# MANATEE COUNTY FLORIDA

SUBJECT: **Invitation for Bid # 09-2568-OV**  
Buffalo Road Re-Alignment (North of Erie Road) and Waterline Relocation  
Project, Palmetto, FL  
**(Project No. 307.6062260)**

## ADDENDUM # 1

**Attachment 3**  
**Engineer's Response to Questions**  
**and Answers**  
**Road Realignment**  
**(8) Total Pages**

SHEET 1 OF 1

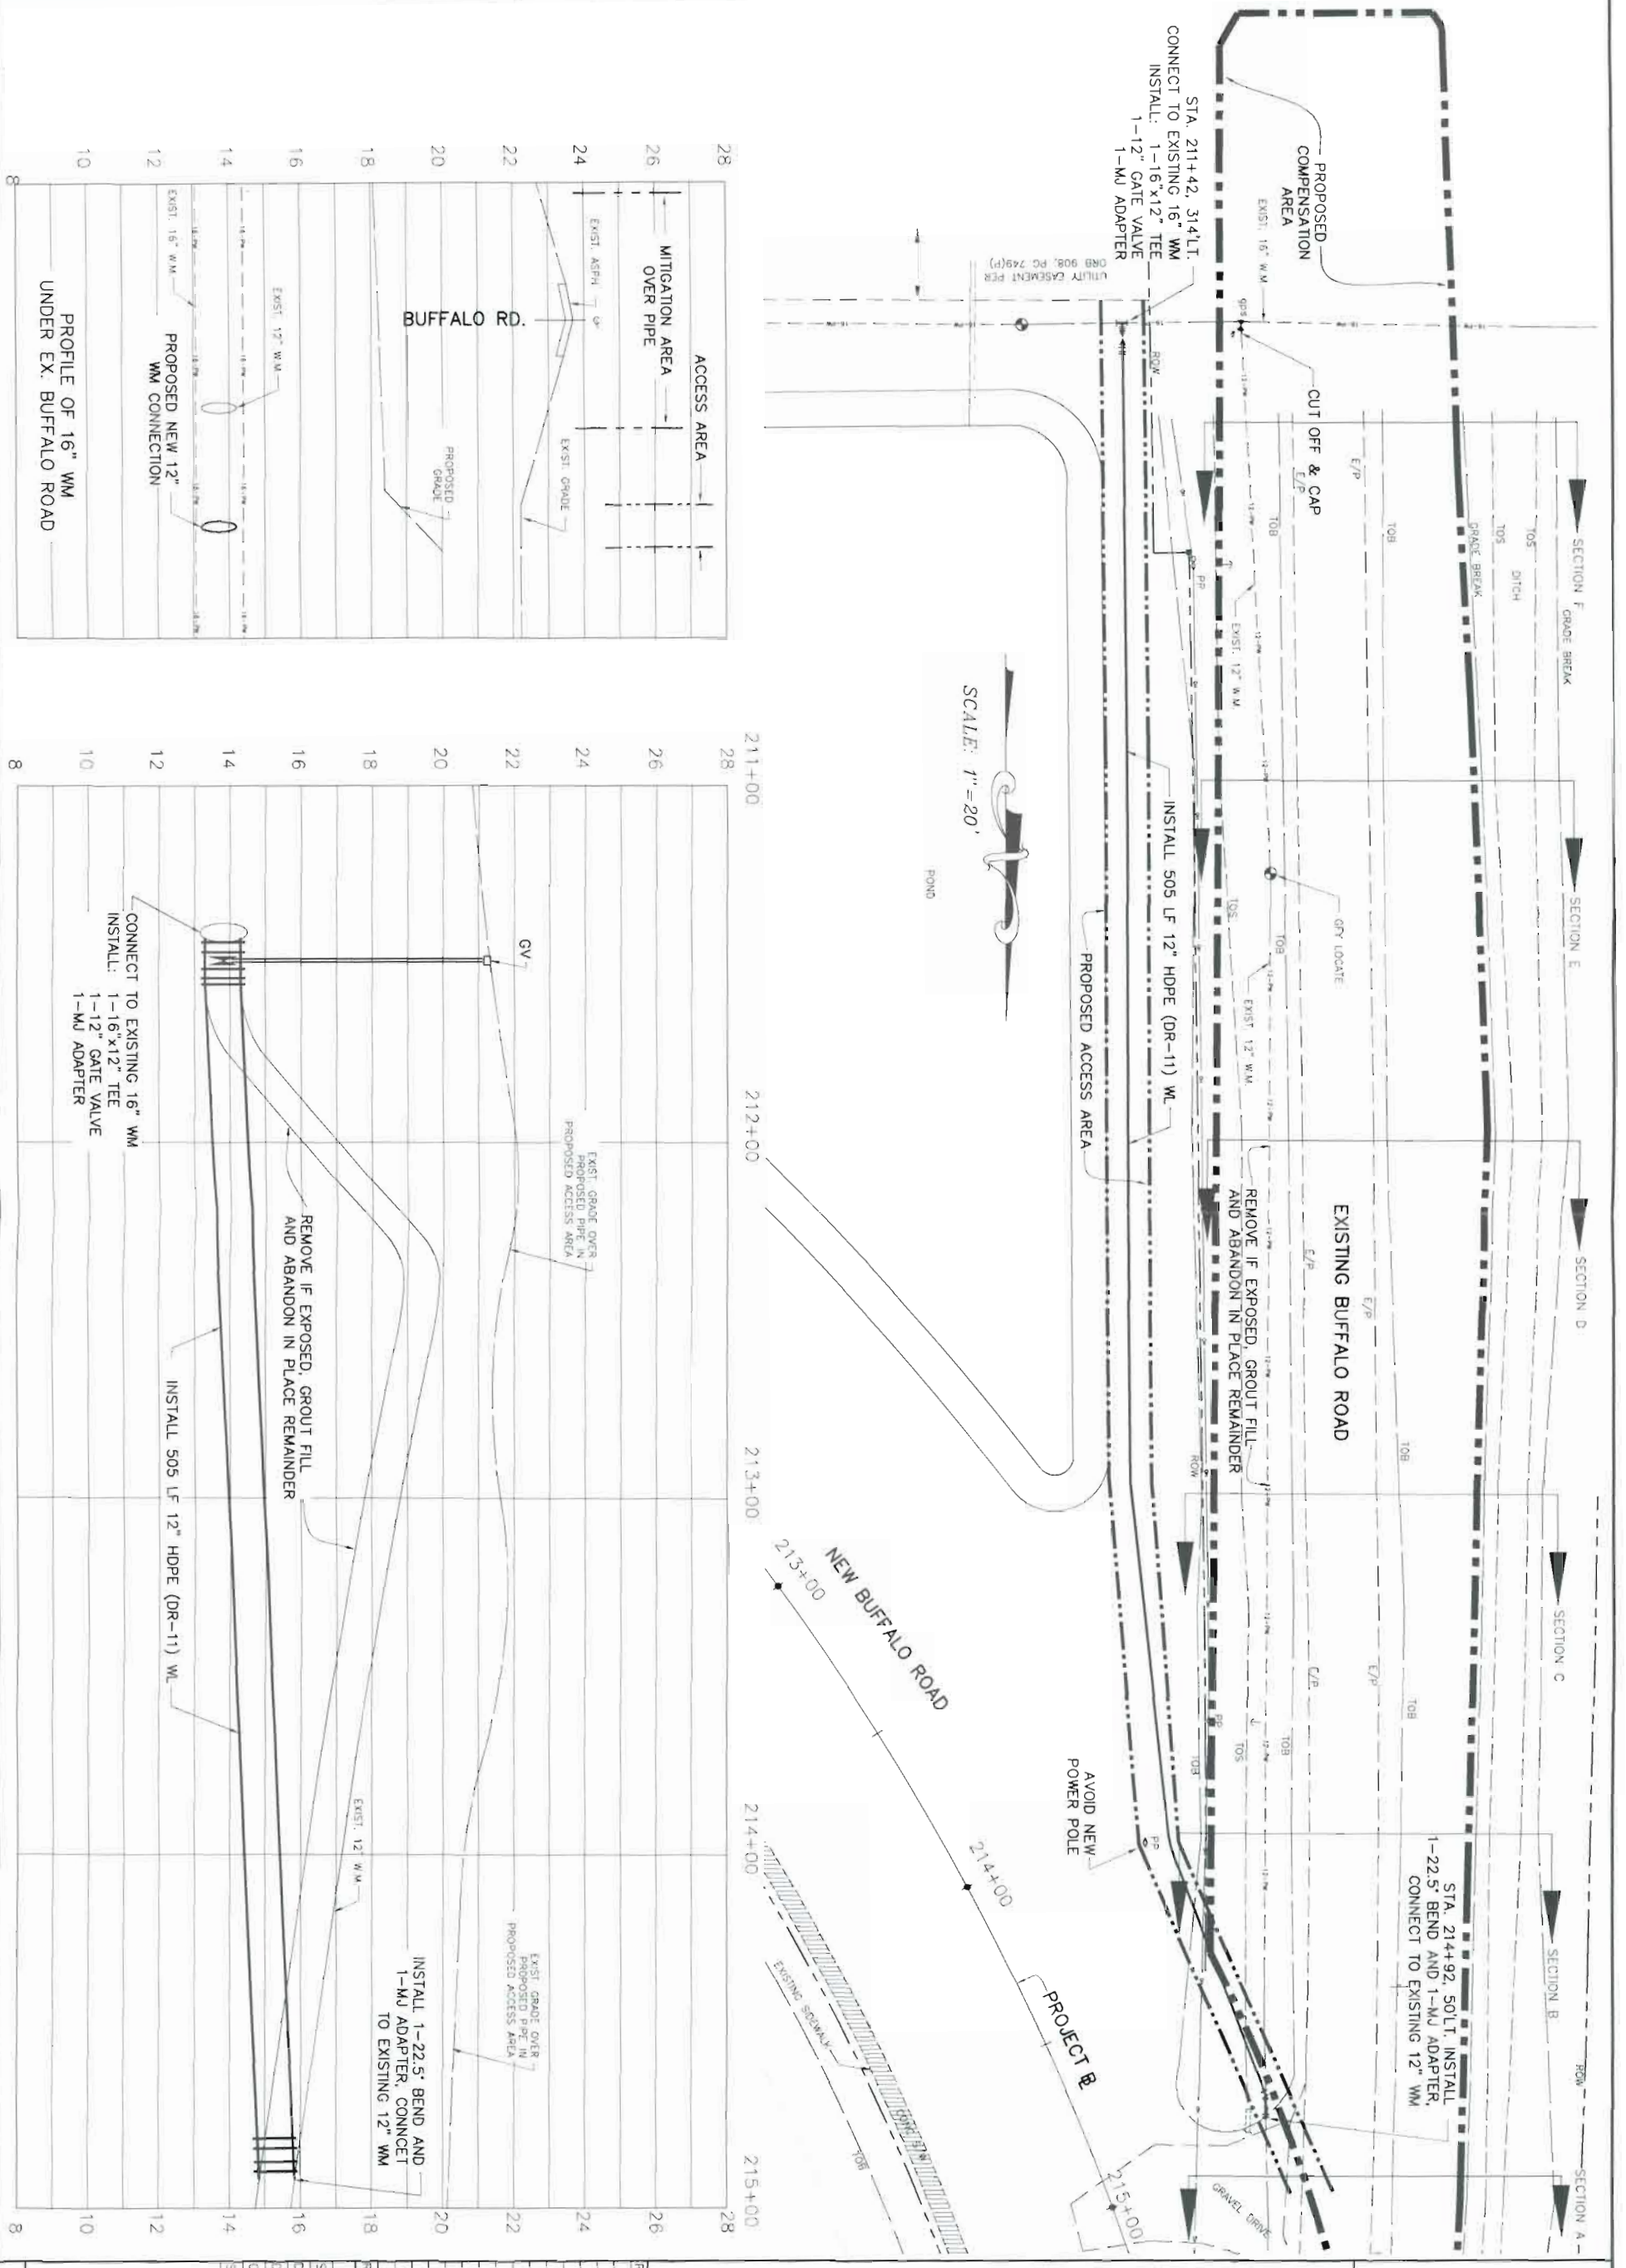
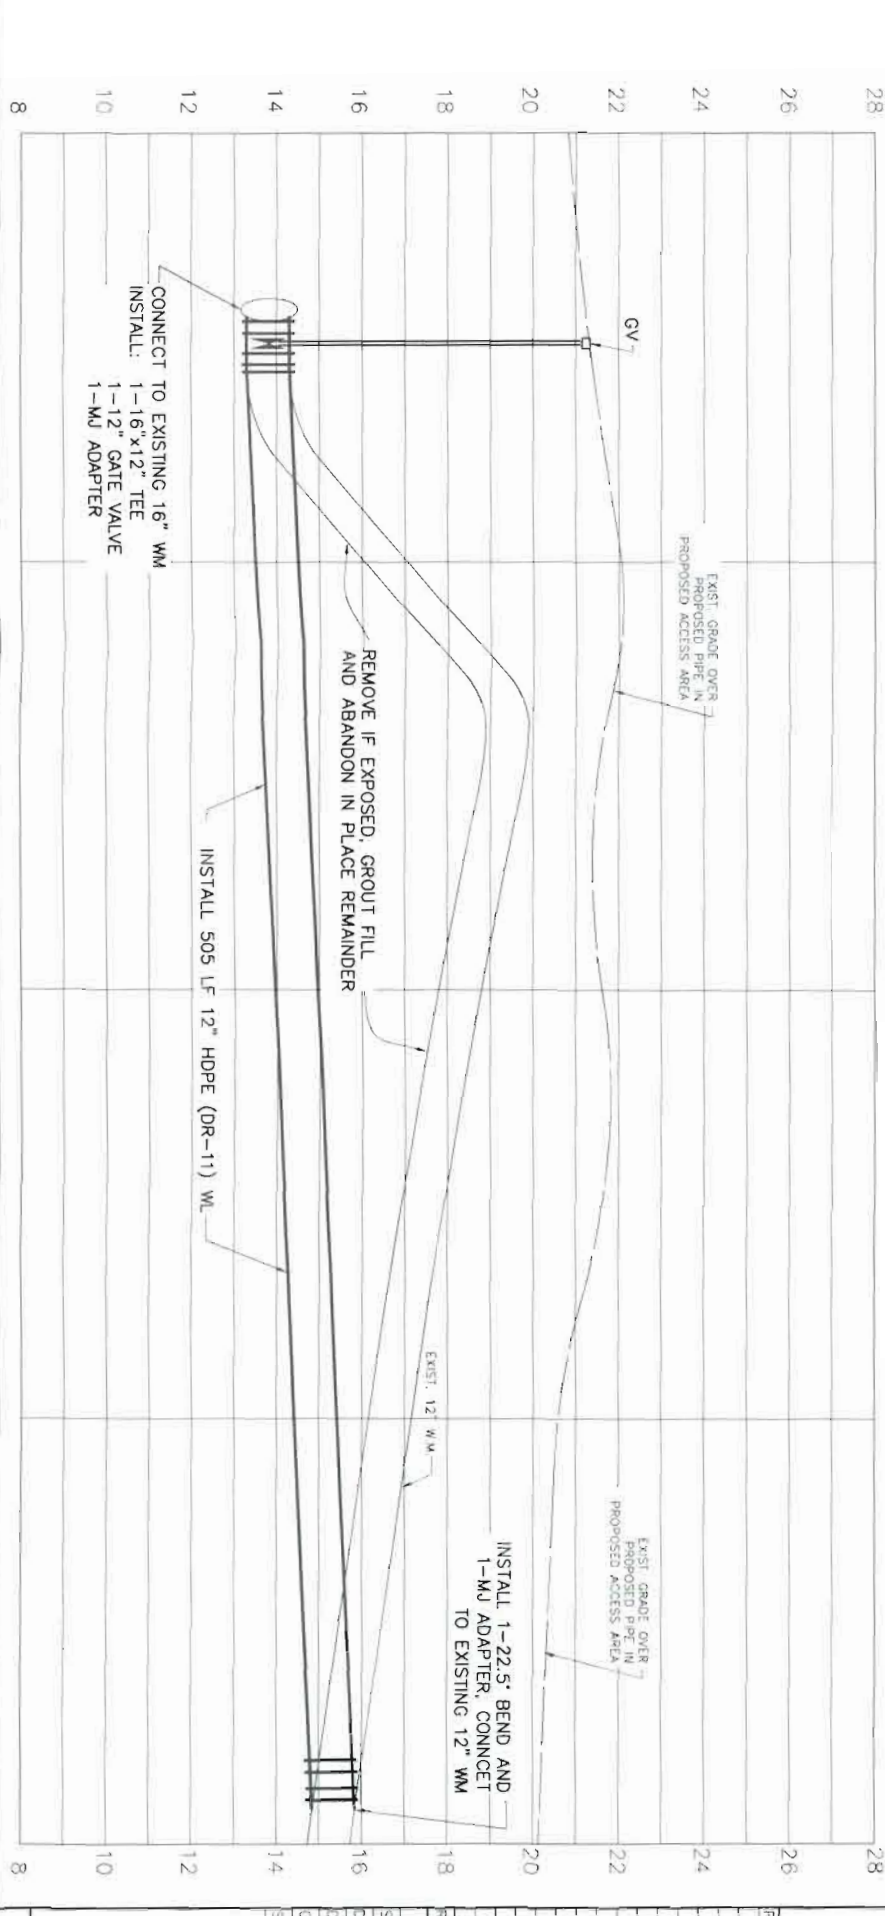
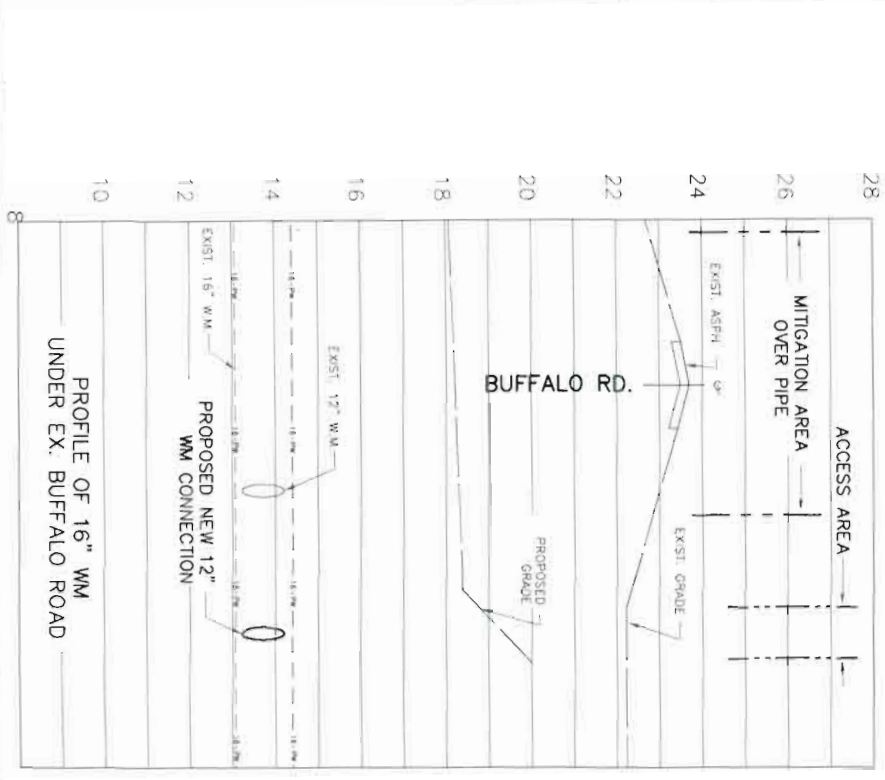
RELOCATE & ABANDON / REMOVE 12" WATERLINE  
IN COMPENSATION AREA

2 - Relocate and remove or abandon / grout fill 505' +/- of the existing 12" PVC potable waterline under part of the existing alignment that is to be cut down for a new compensation area. See plan sheet 1 of 1, approximate stationing 211+42, 314' LT to 214+92, 50' LT

REV. 1. EDITS 08/04/09

**ERIE ROAD SIGNALIZATION PLAN**

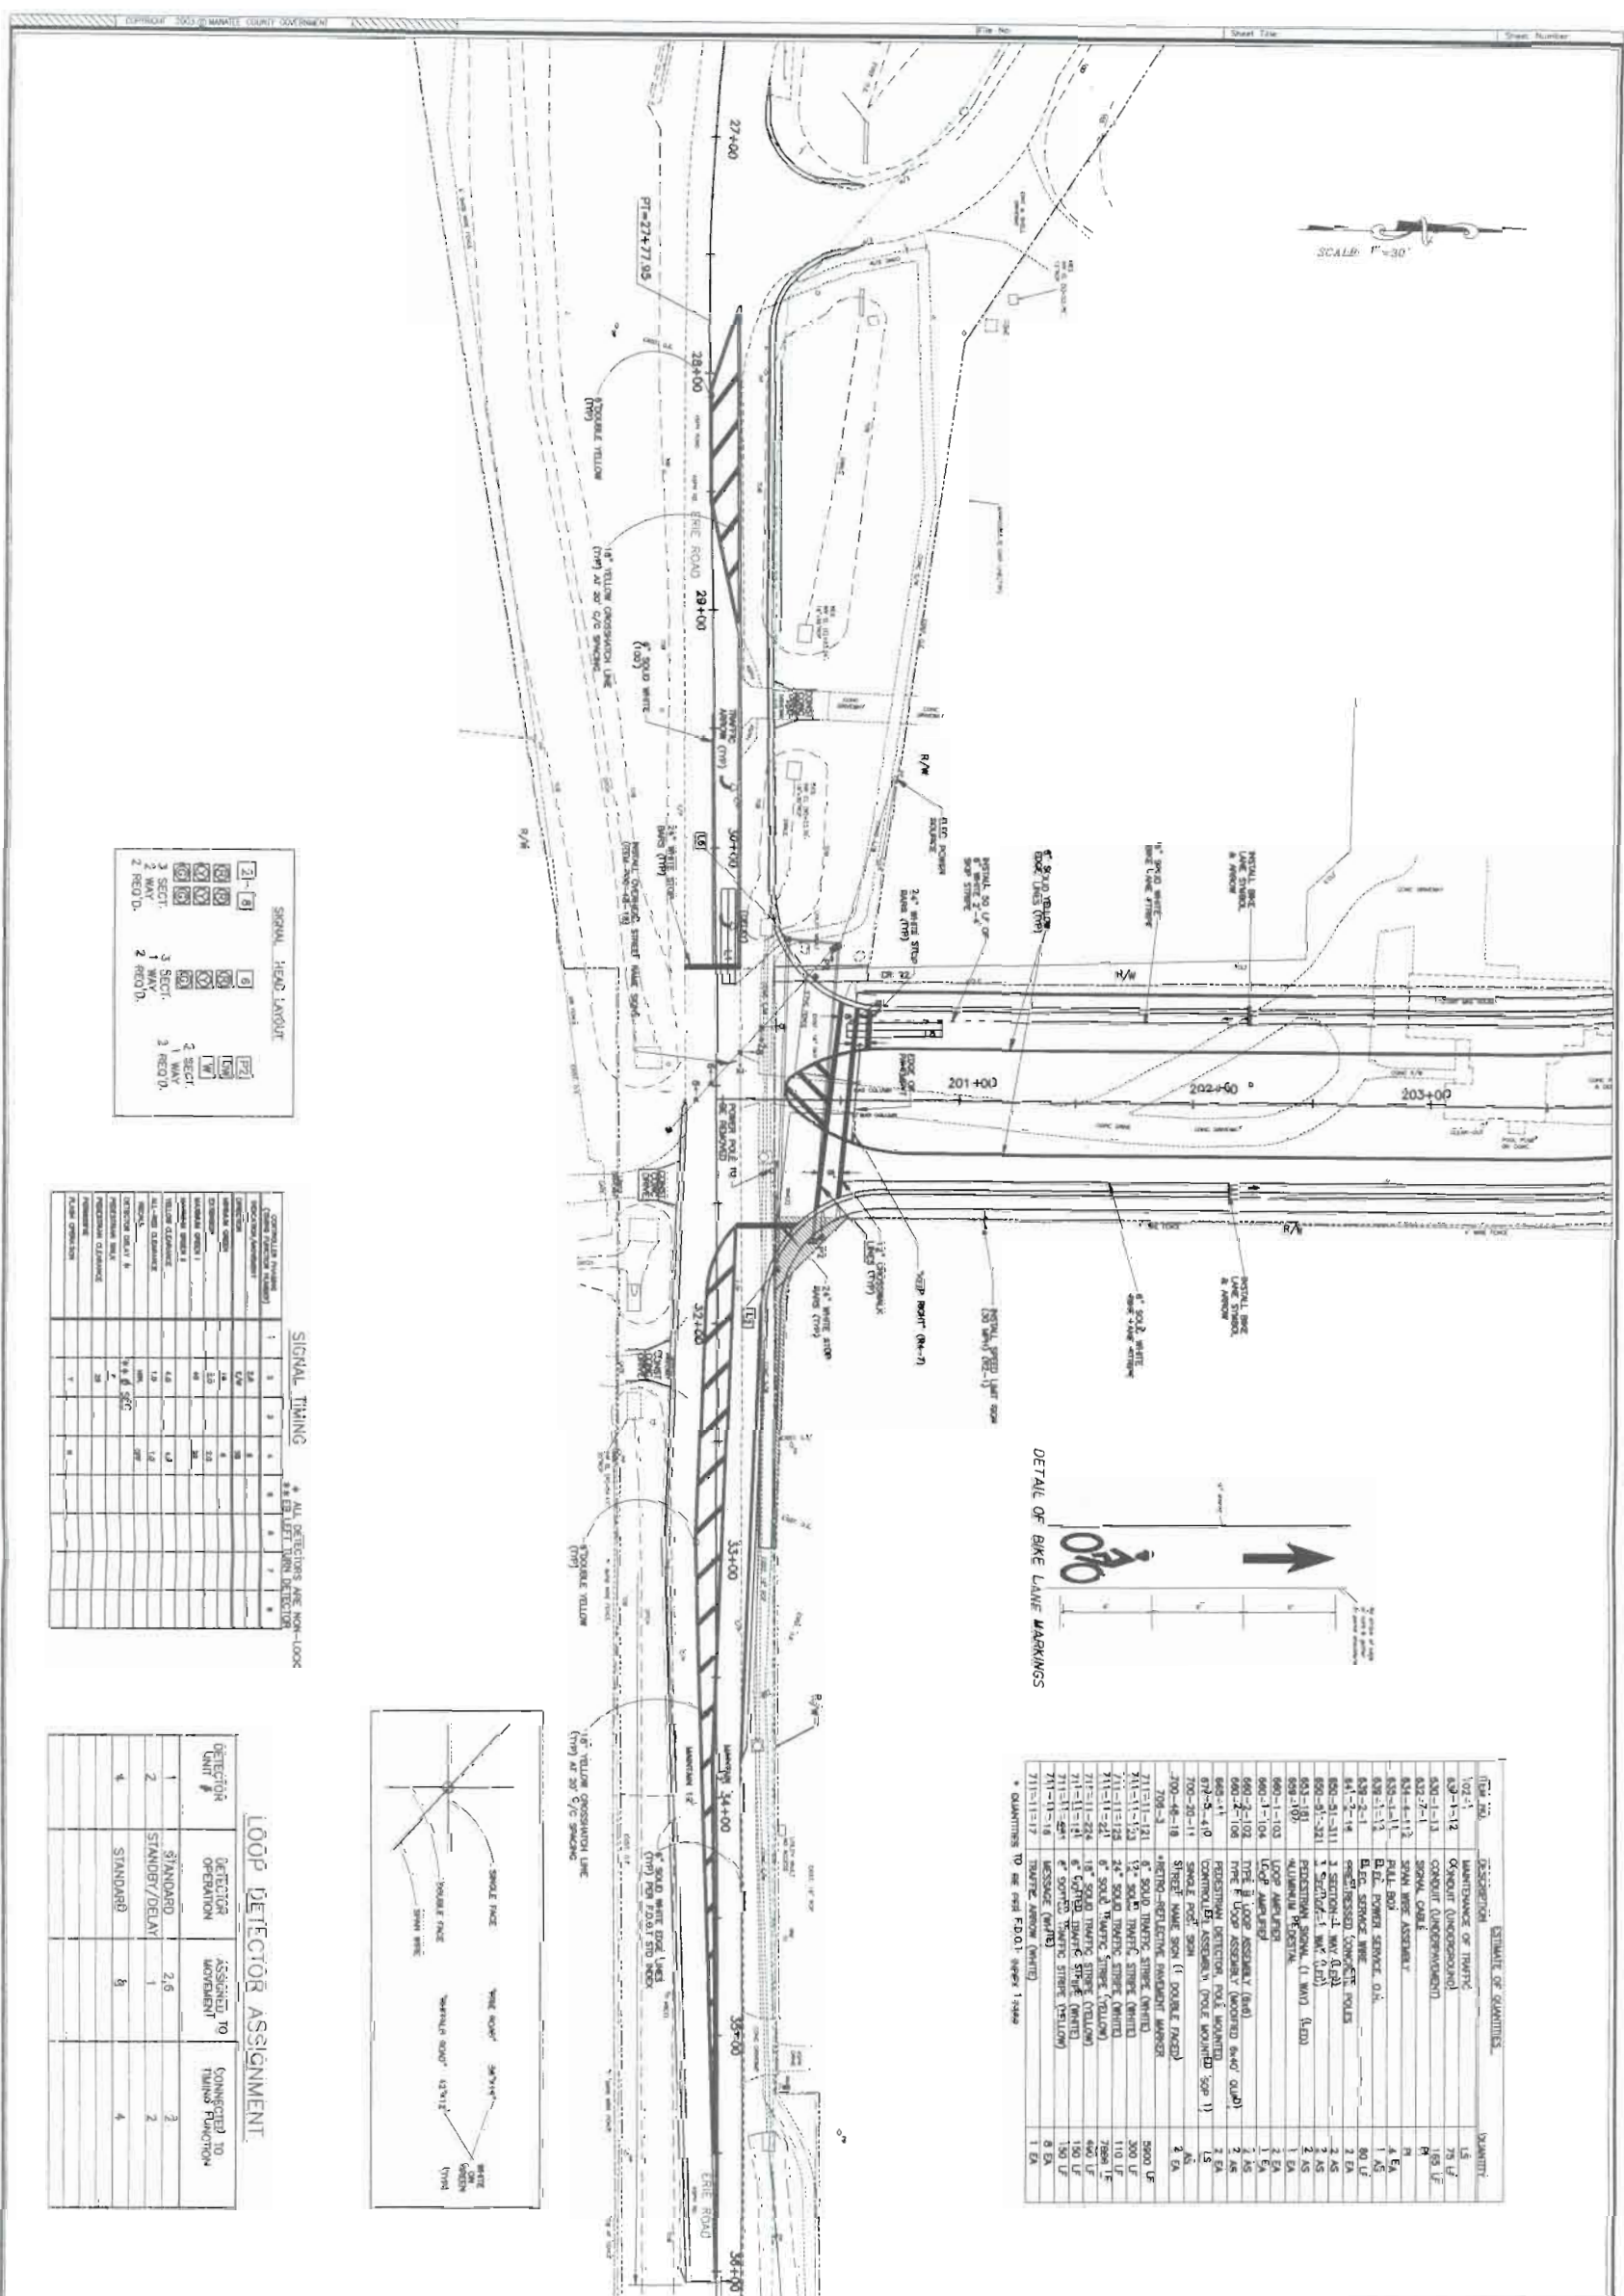
Q-9: Within the plans I did not see any details for the signalization scope of work. May this be provided?

Ans: Scope of work for signalization is provided with the design plans in Addendum 1, see sheet SP-9 (Signalization Plan).
